Technical Note 3 – 2nd Response to National Highways

Project Name:	Fryatts Way, Bexhill	Office:	Manchester
Project No.:	784-A115791	Prepared by:	M Thompson
Date:	17.06.2022	Checked by:	M Thompson
Status:	For Information	Approved by:	L Regan

- 1.1 This Technical Note (TN3) has been produced to respond to the National Highways (NH) comments dated 21 March 2022 on Rother District Council (RDC) planning application reference RR/2021/1656/P.
- 1.2 The planning application package submitted included a Transport Assessment (TA) produced by Tetra Tech (Tt). A previous Technical Note (TN1) was submitted in response to NH comments dated 18 October 2021. Further comments were then received in March 2022, which are responded to within this Technical Note (TN3).
- 1.3 The planning application is for up to 210-dwellings on Land off Fryatts Way in Bexhill.
- 1.4 The NH comments are attached at **Appendix A**. Their comments cover:
- 1) Personal Injury Accident Review
 - 2) Committed Developments
 - 3) Trip rates
 - 4) Assessment Years
 - 5) Traffic Impact Assessment
- 1.5 Each of those matters are dealt with in sub-sections of this TN3.

Figures v2: Fig 32: 2025 Assessment Flows for Mitigation at J7 (Baseline + Committed Development + Development (Sensitivity) + Bexhill Lesuire Re-dev) - AM Peak Hour

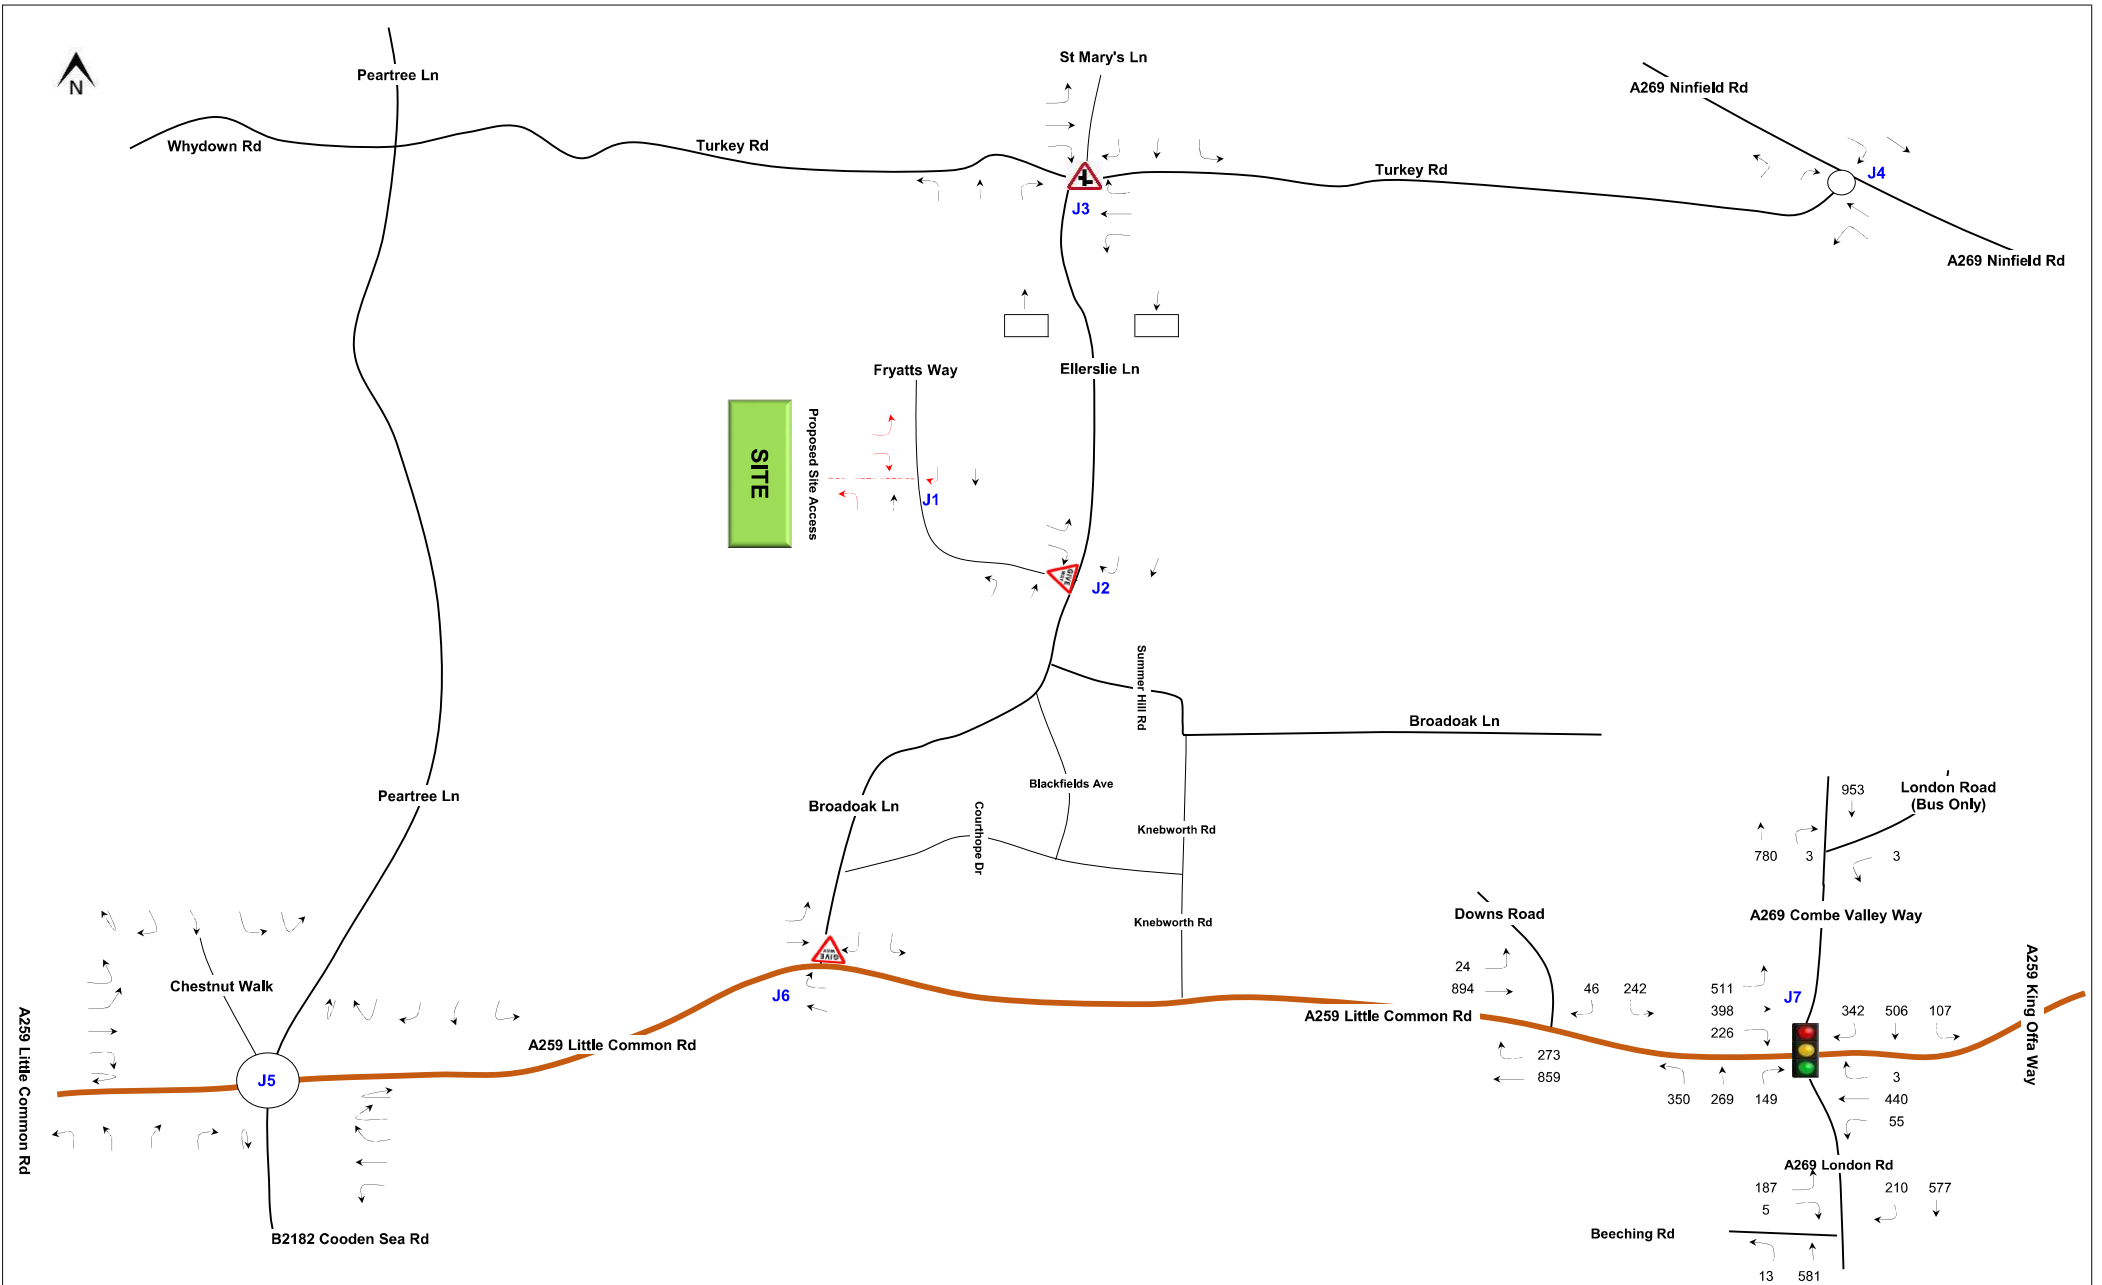
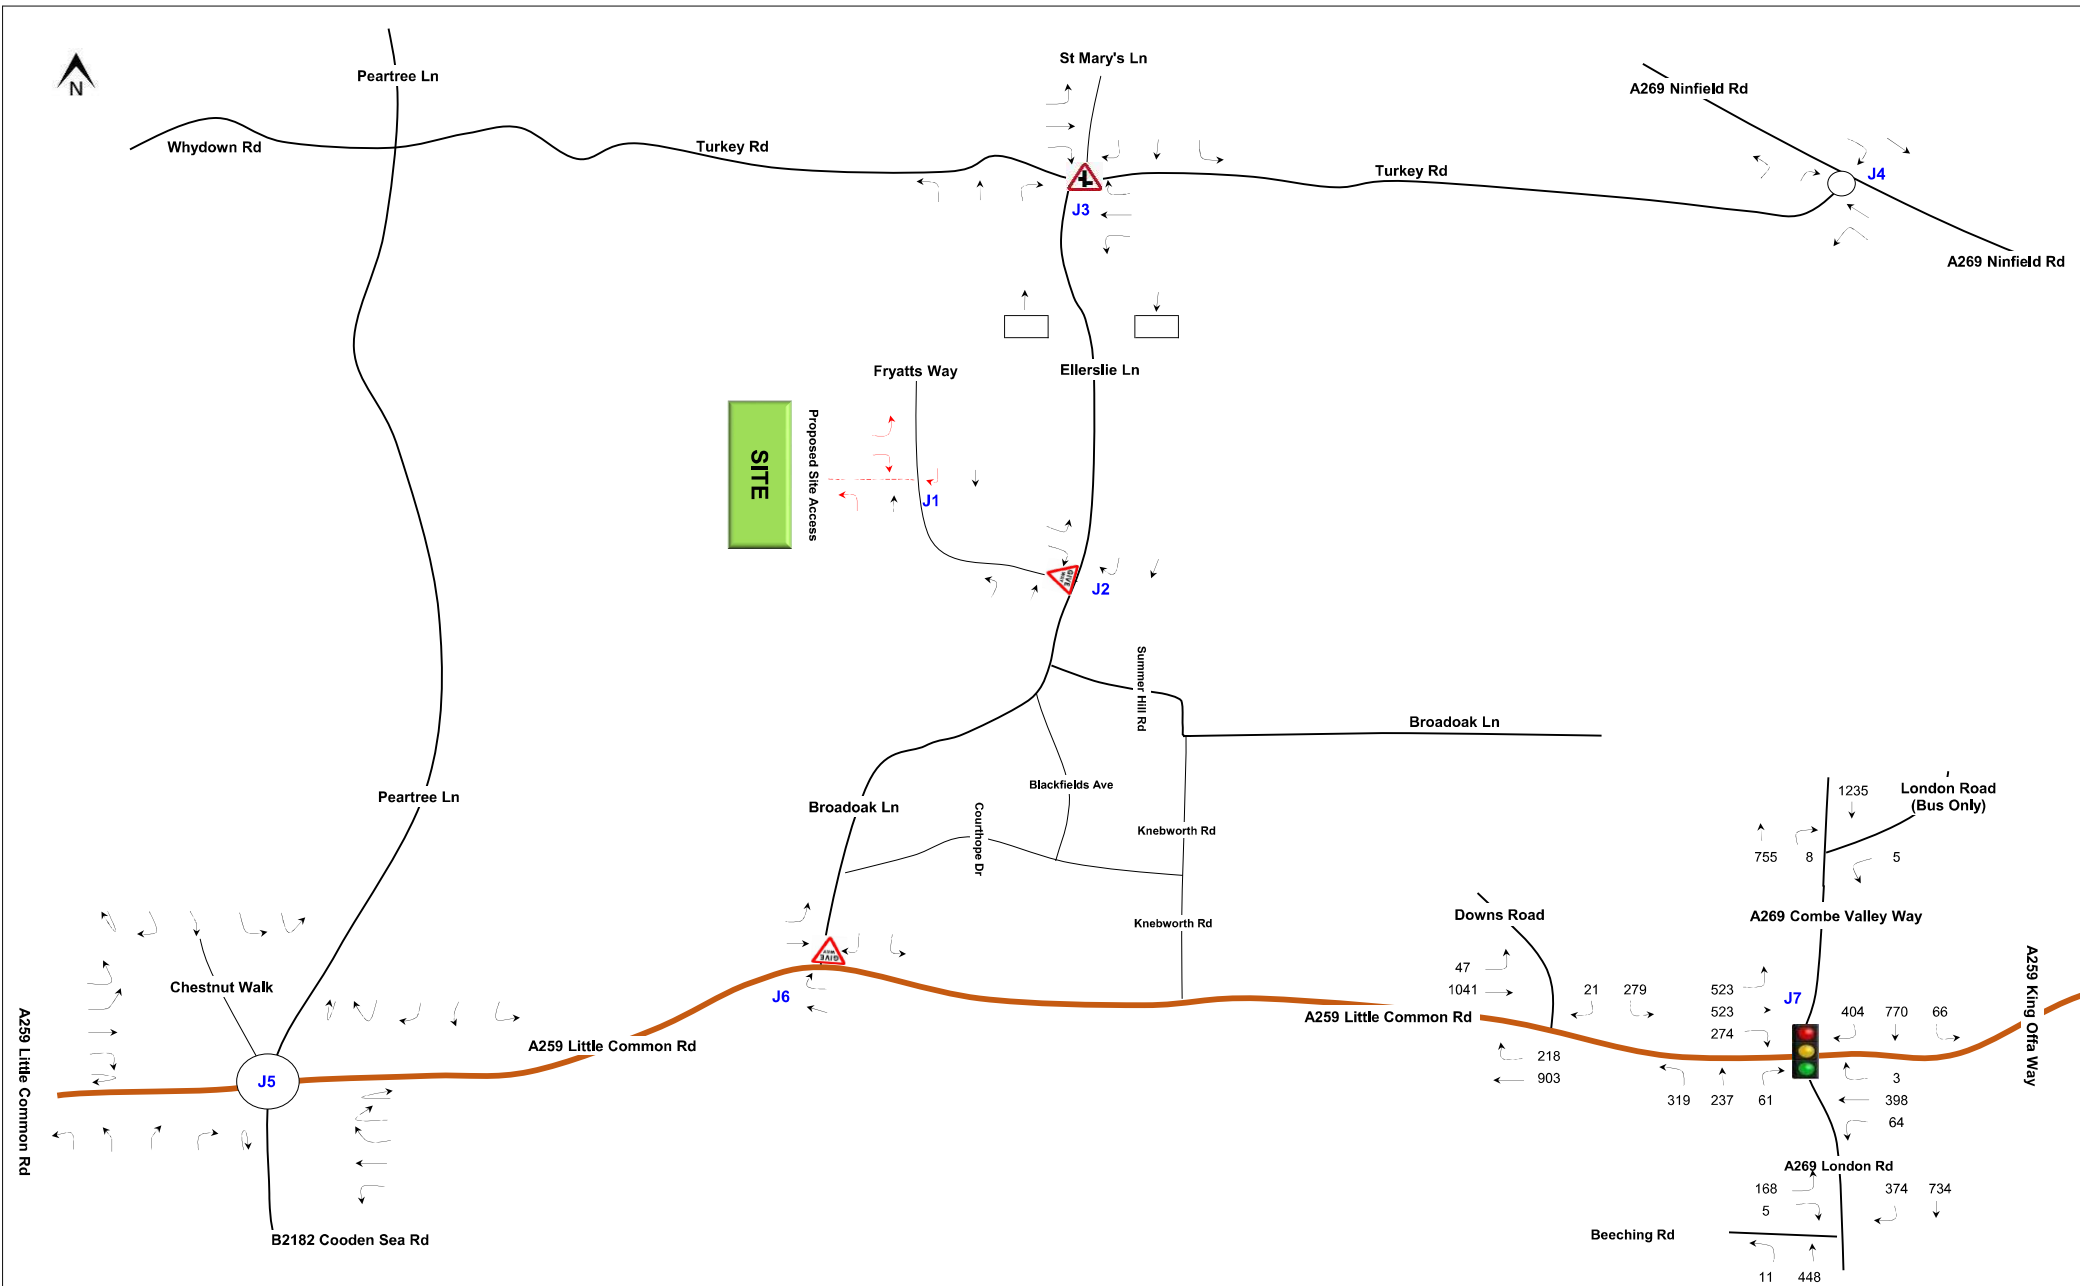
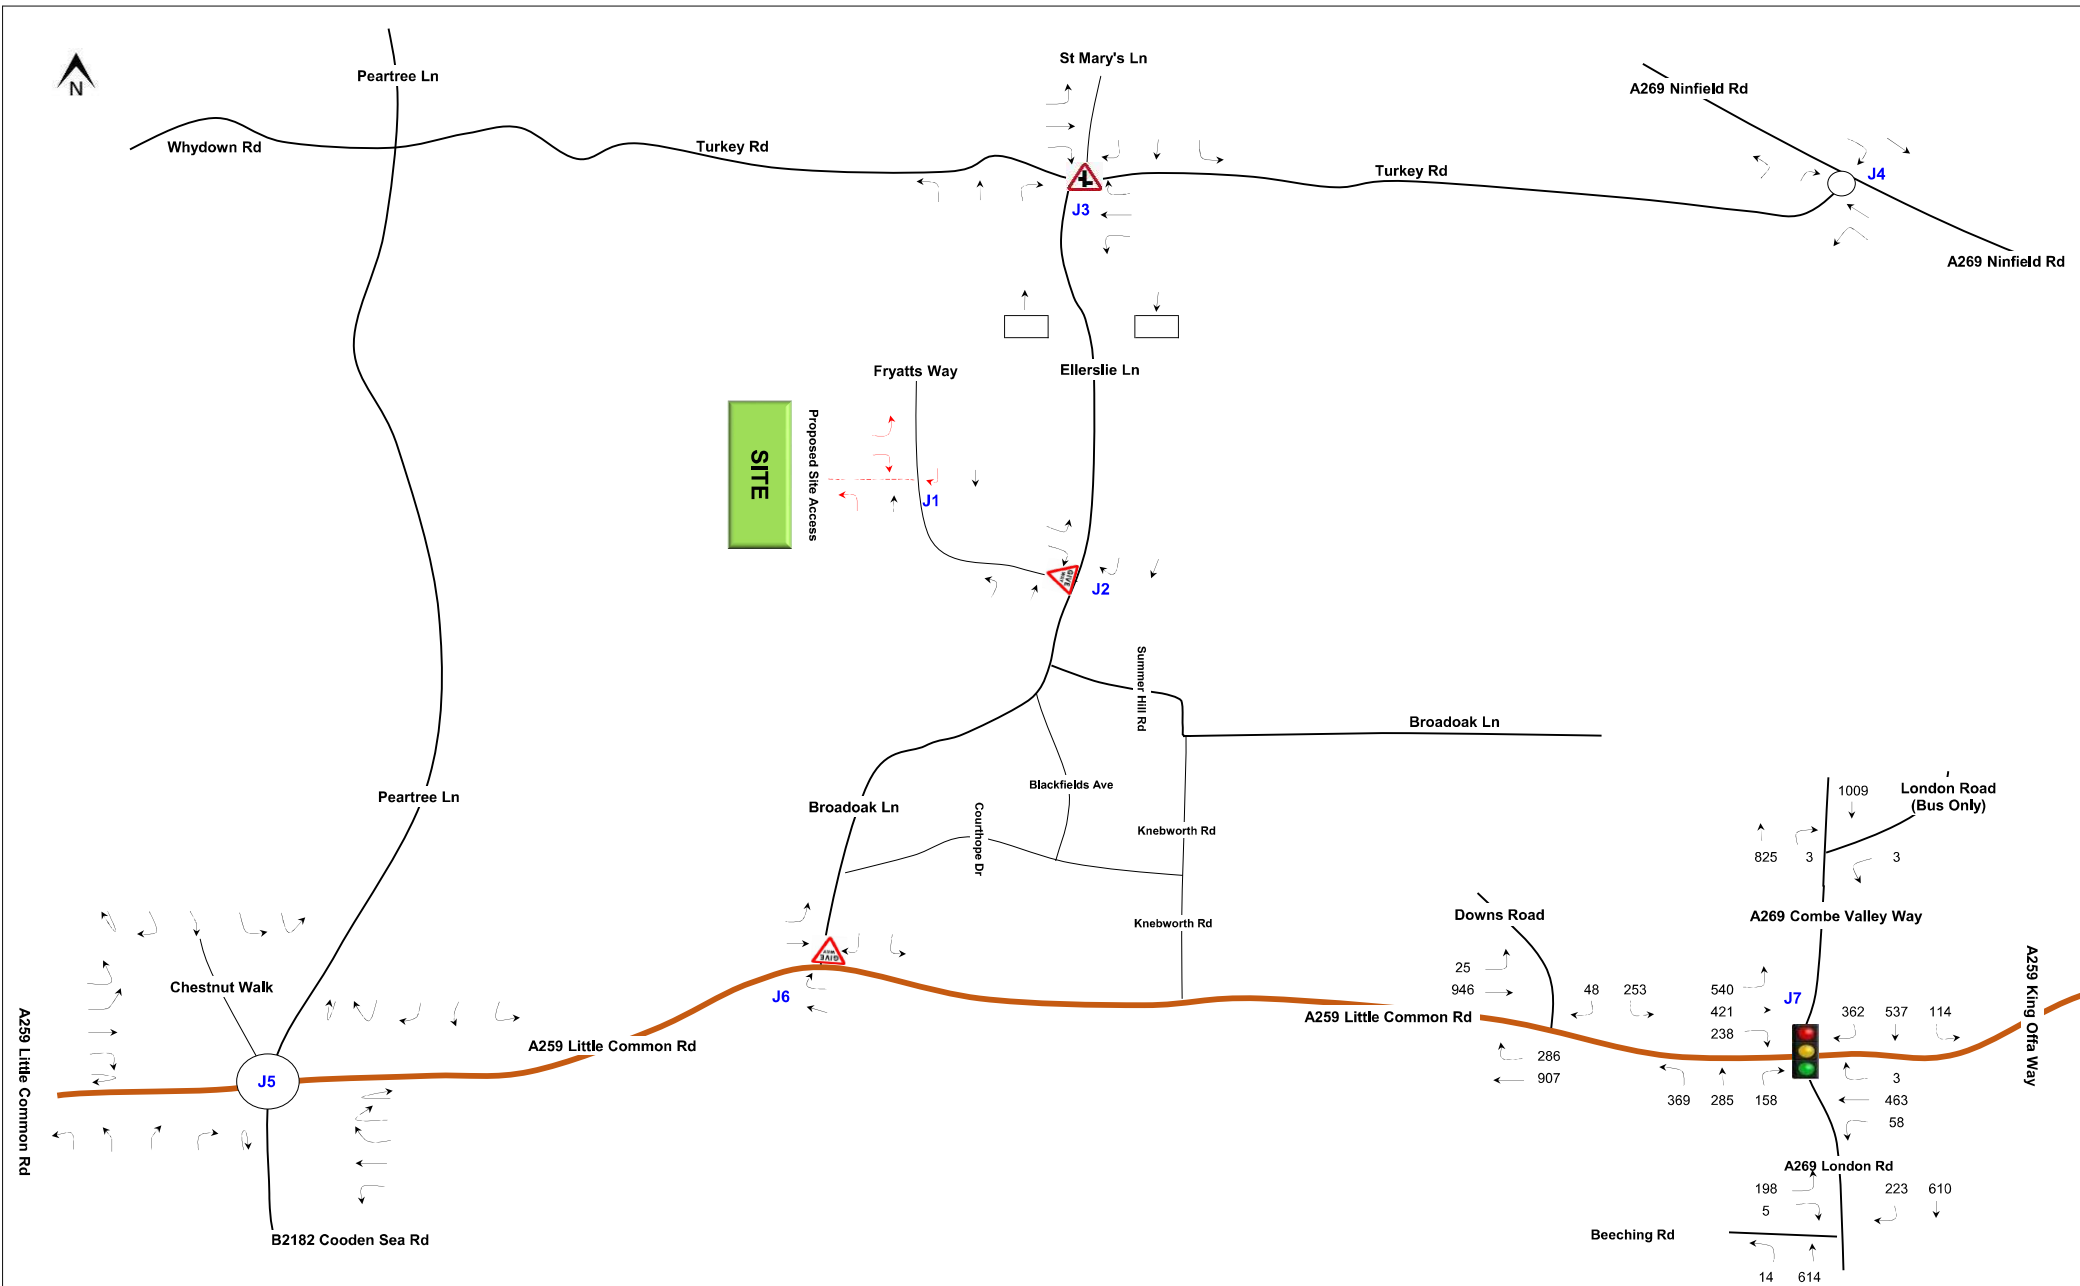
The A259/A269 signalised junction LinSig model is based on the existing layout rather than the mitigation scheme for the redevelopment of Bexhill Leisure Centre (RR/2019/430/P). Although the planning application is undecided, the development is an allocation in the adopted Rother Local Plan (BEX4) and the mitigation at A259/A269 is required to deliver Local Plan development, not just BEX4. Therefore, the development and associated mitigation should be assumed in 2031 future year assessments. However, we recognise that the Bexhill Leisure Centre redevelopment proposal is currently suspended and so an assessment based on the existing layout could be undertaken as an additional test.

- 6.8 An assessment of the Bexhill Leisure Centre mitigation scheme including the Bexhill Leisure Centre traffic flows (see **Appendix C**) has been included in the updated traffic impact assessment included in Section 7 of this TN.

7.17 NH have also requested that a potential mitigation scenario at this junction is modelled. A planning application for the redevelopment of Bexhill Leisure Centre (RR/2019/430/P) identifies a mitigation layout and although the planning application is undecided, the development is an allocation in the adopted Rother Local Plan (BEX4) and the mitigation at A259/A269 is required to deliver Local Plan development. Therefore, an assessment of the 2031 future year assessment flows including the Bexhill Leisure Centre flows on the mitigation layout has been undertaken and the results are shown in **Table 7.7**. For robustness, the Development flows included in the Mitigation assessment are the Sensitivity Test 0.7 trip rate flows. The LinSig model output for the Mitigation layout is attached as **Appendix I**.

7.18 **Table 7.7** shows that the proposed mitigation layout is forecast to operate with spare capacity in the 2025 opening year scenario, with the Bexhill Leisure Centre re-development flows and the Sensitivity test 0.7 trip rate for the development traffic.
